Addendum No. 1
City of Coquitlam
Tender No. 78012
Road & Pedestrian Safety Improvements on Guildford Way
and David Avenue
 (Consists of 7 Pages)
 Issue Date: April 7, 2026

Project: **GUILDFORD WAY FALCON DRIVE**
Description: **TRAFFIC SIGNAL MODIFICATIONS**
File: 8358-24

Project **GUILDFORD WAY**
LANSDOWNE DRIVE
Description **TRAFFIC SIGNAL MODIFICATIONS**
File: 8358-24

Design by	Date	Scale
BP	12-12-2024	1:250
Drawn by	Date	Sheet of
YJ	12-12-2024	1 OF 4
Checked by	Date	Eng. Project No.
NB	12-12-2024	
Approved by	Date	
	12-12-2024

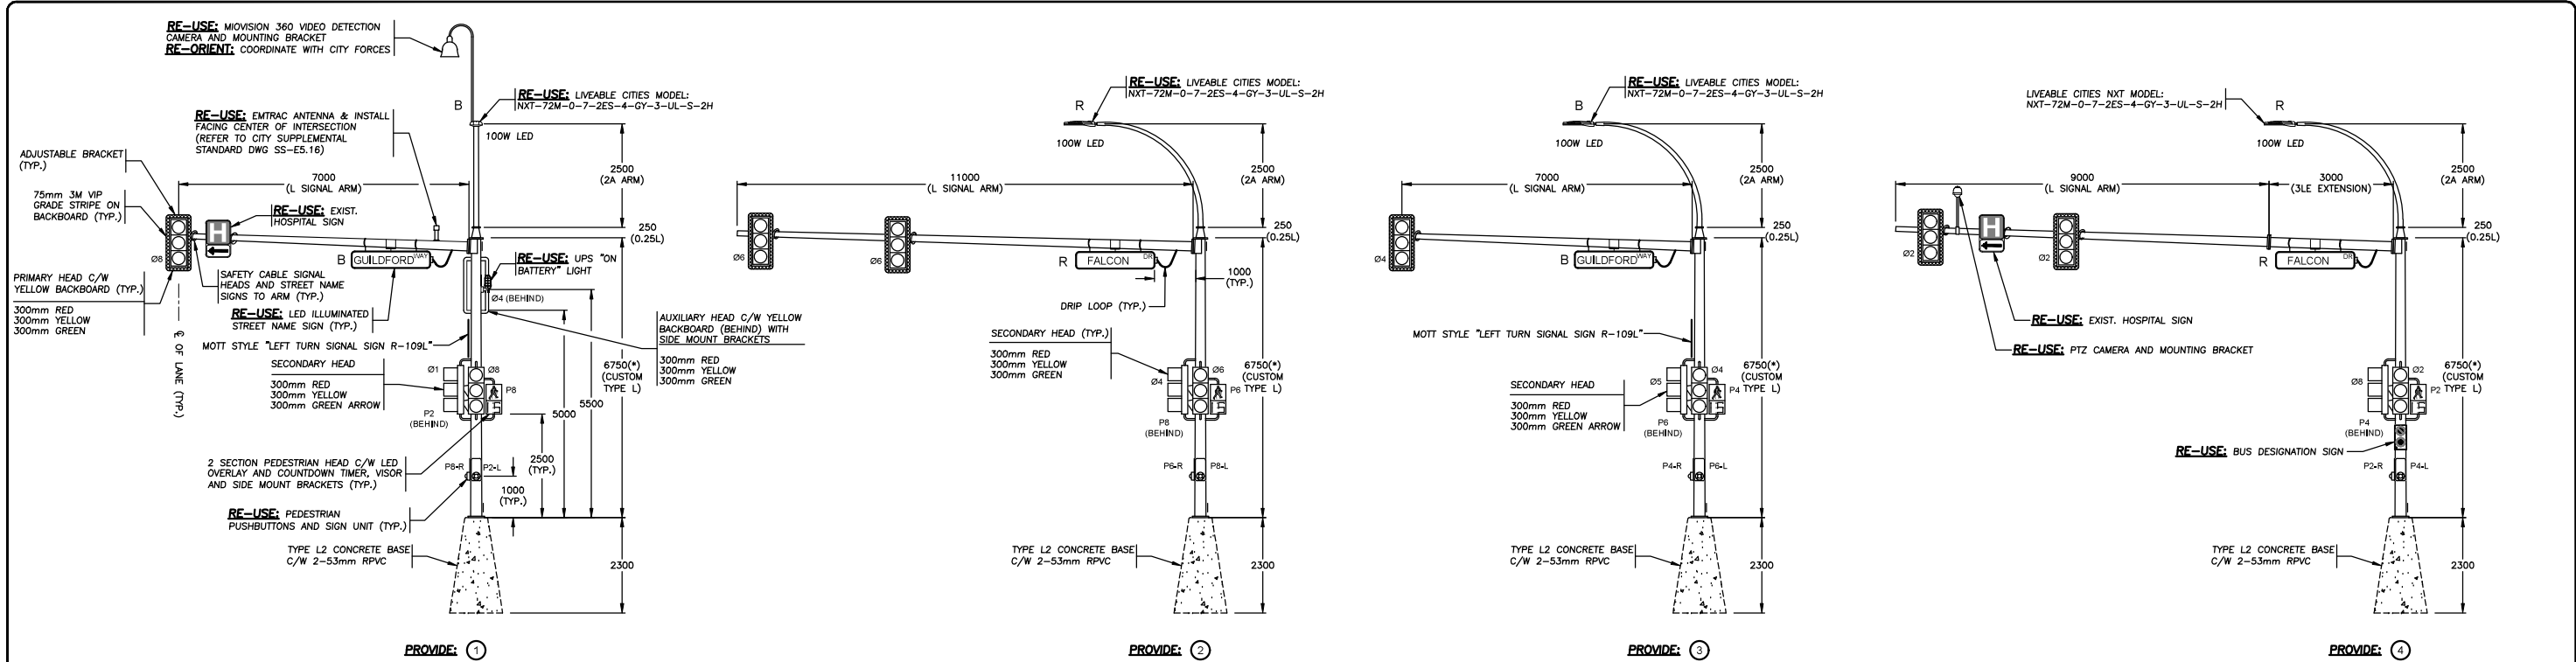
No.	Date	By	Revisions
1	02-04-2026	BG	ADDENDUM #1 SOUTH CORNER POLE AND JB SHIFT
	05-03-2026	BG	ISSUED FOR TENDER
	21-01-2026	BG	DETAILED SUBMISSION
	28-04-2025	BP	PRELIMINARY SUBMISSION

Design by	Date	Scale
BP	12-12-2024	AS NOTED
Drawn by	Date	Sheet of
YJ	12-12-2024	2 OF 4
Checked by	Date	Eng. Project No.
NB	12-12-2024	
Approved by	Date	
	12-12-2024

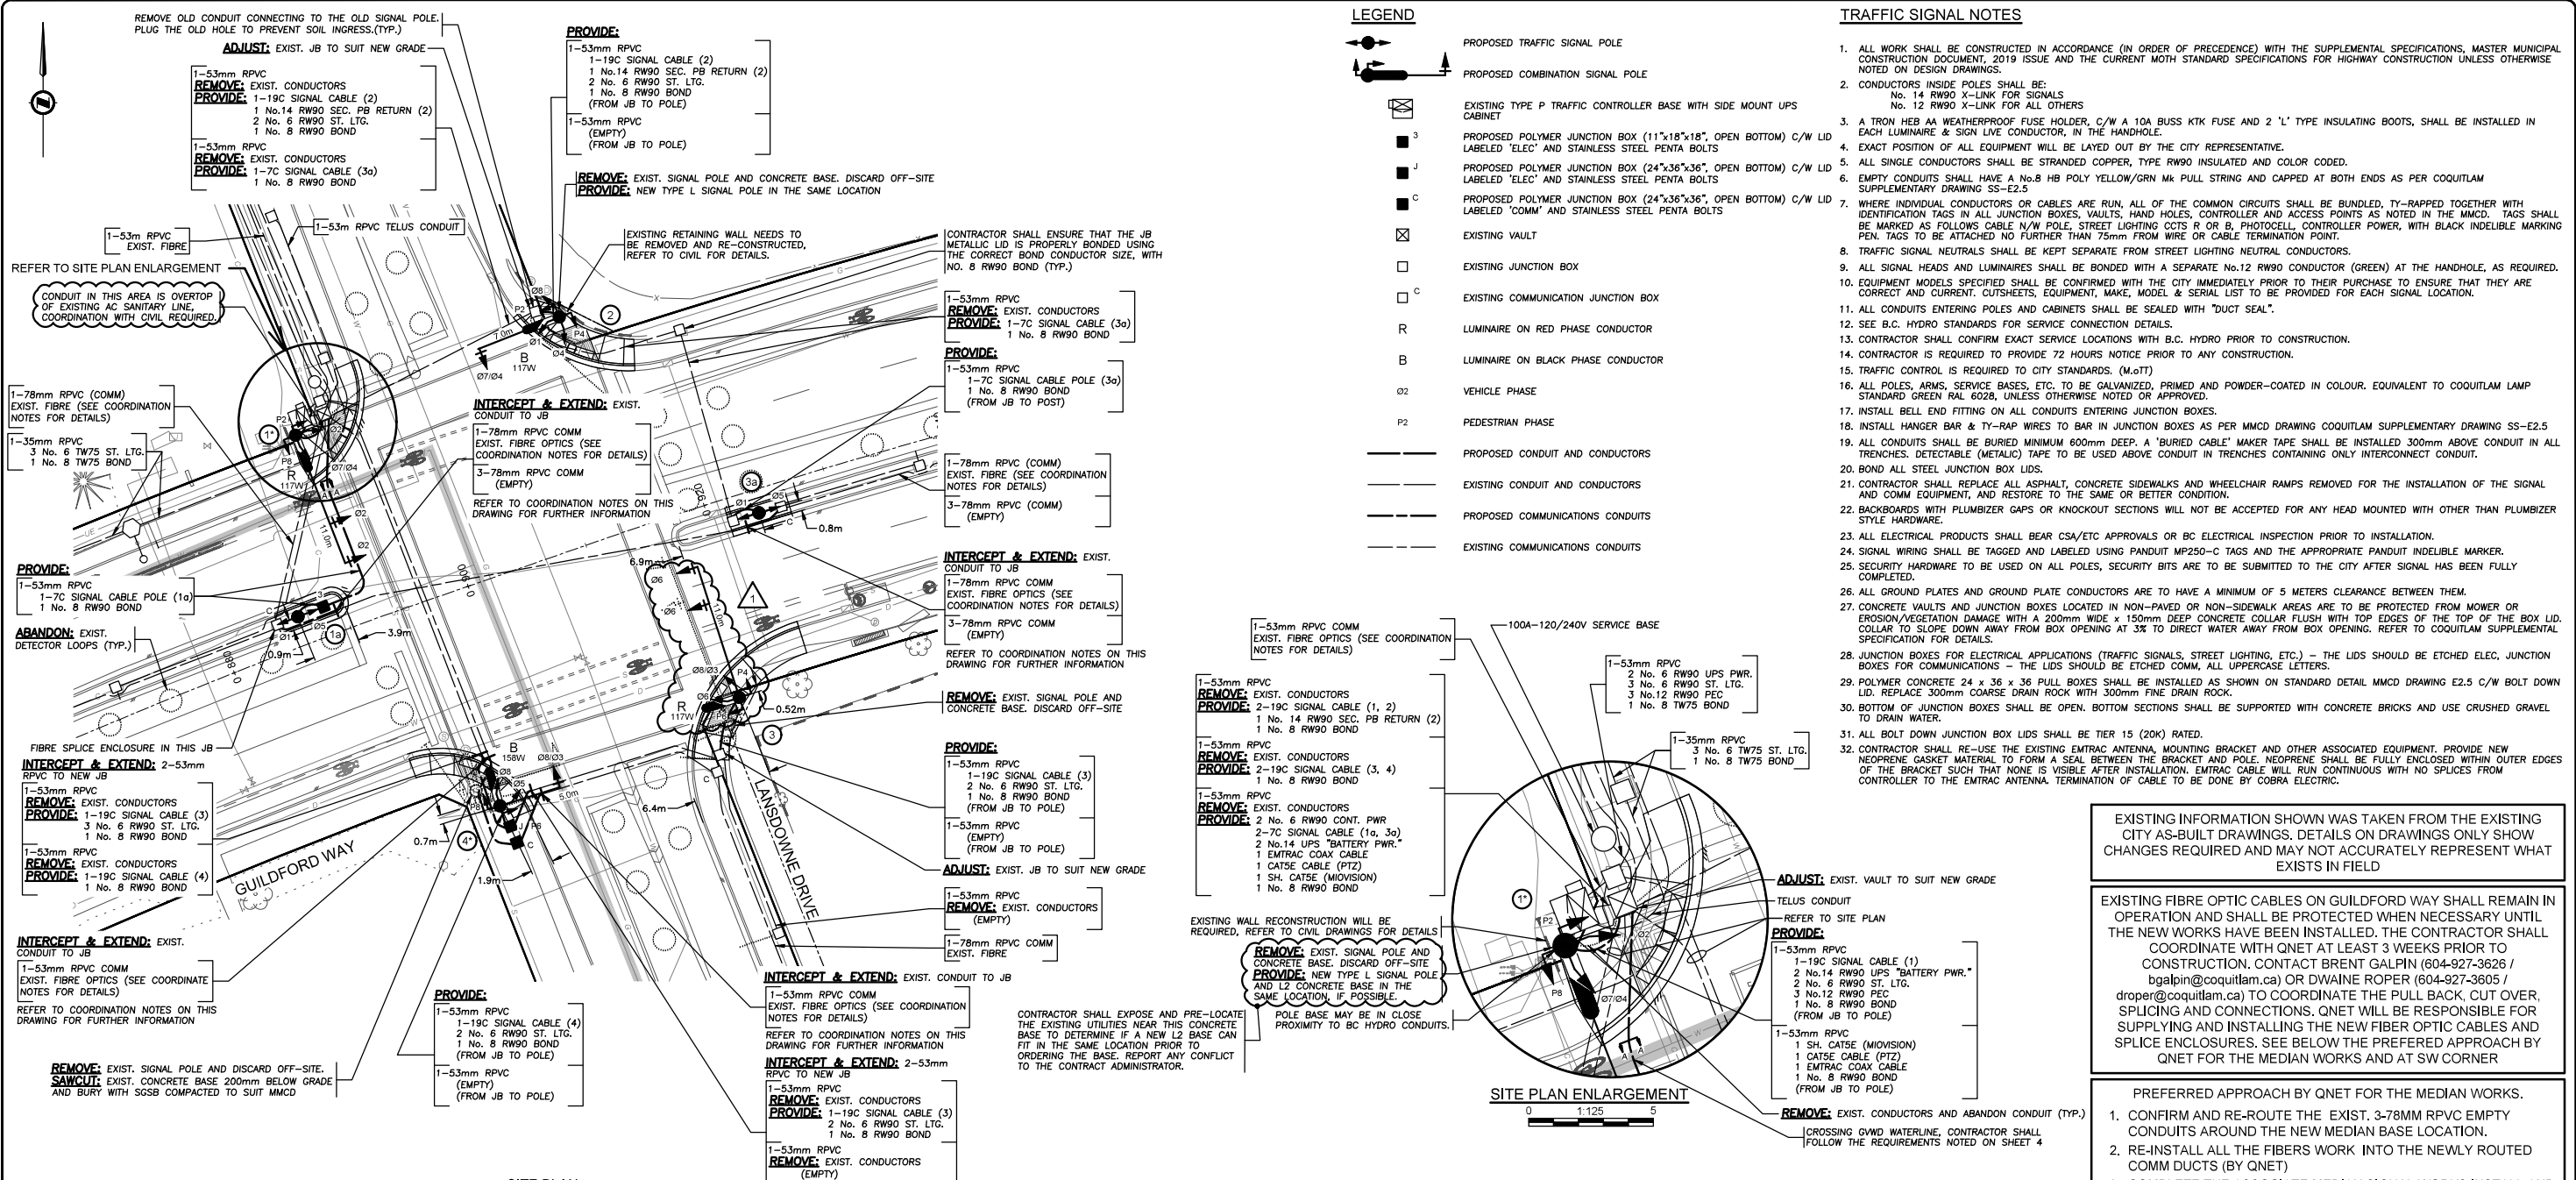
No.	Date	By	Revisions
1	02-04-2026	BG	ADDENDUM #1 SOUTH CORNER POLE AND JB SHIFT
	05-03-2026	BG	ISSUED FOR TENDER
	21-01-2026	BG	DETAILED SUBMISSION

Design by	Date	Scale
BP	12-12-2024	1:250
Drawn by	Date	Sheet of
YJ	12-12-2024	3 OF 4
Checked by	Date	Eng. Project No.
NB	12-12-2024	
Approved by	Date	
	12-12-2024

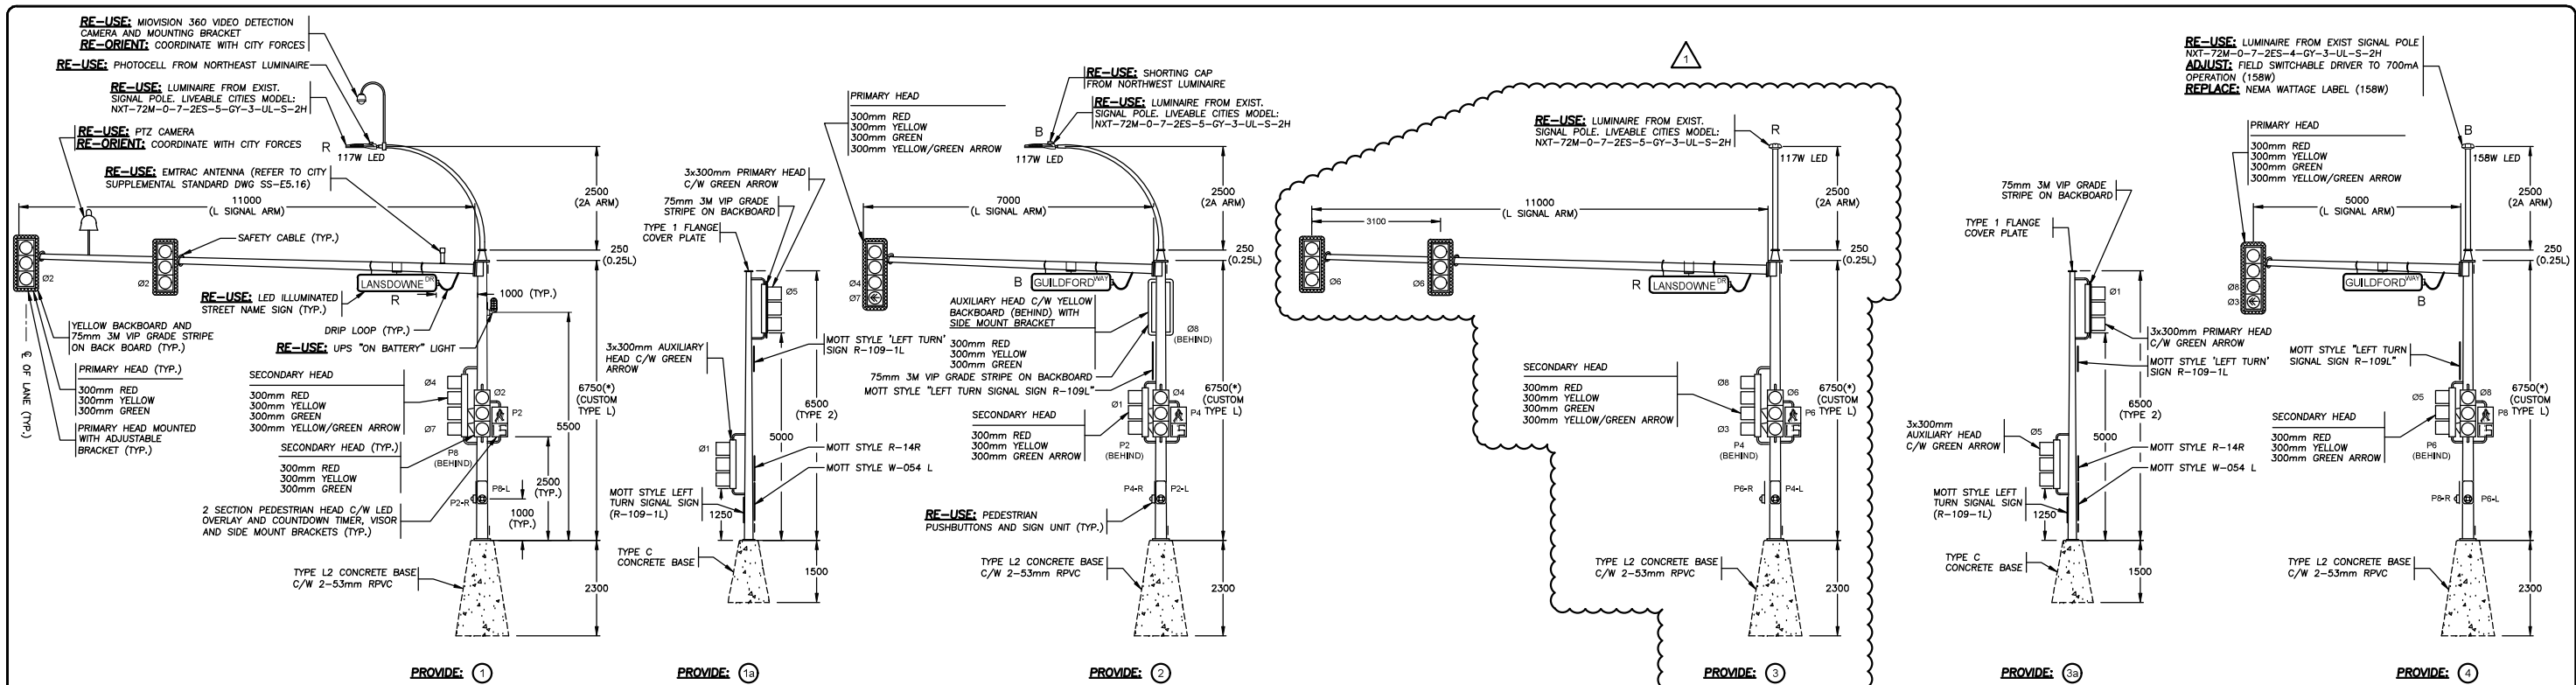
No.	Date	By	Revisions
1	02-04-2026	BG	ADDENDUM #1 - POLE 2 LOCATION AND POLE TYPE CHANGE
	05-03-2026	BG	ISSUED FOR TENDER
	21-01-2026	BG	DETAILED SUBMISSION
	28-04-2025	BP	PRELIMINARY SUBMISSION

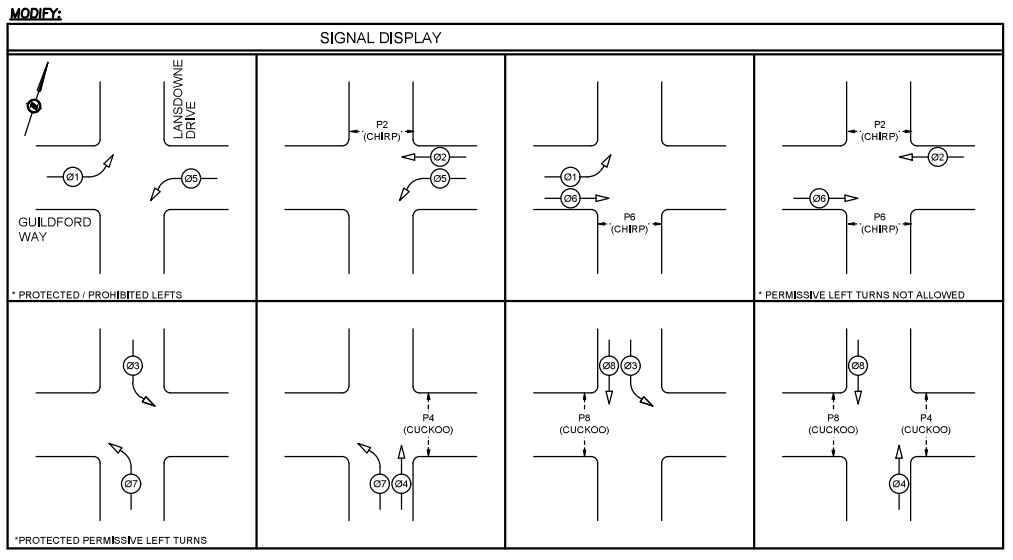
Revisions: 1. 02-04-2026 BG ADDENDUM #1 - POLE 2 LOCATION AND POLE TYPE CHANGE 2. 05-03-2026 BG ISSUED FOR TENDER 3. 21-01-2026 BG DETAILED SUBMISSION	Design by: _____ Date: 12-12-2024 Drawn by: _____ Date: 12-12-2024 Checked by: _____ Date: 12-12-2024 Approved by: _____ Date: 12-12-2024
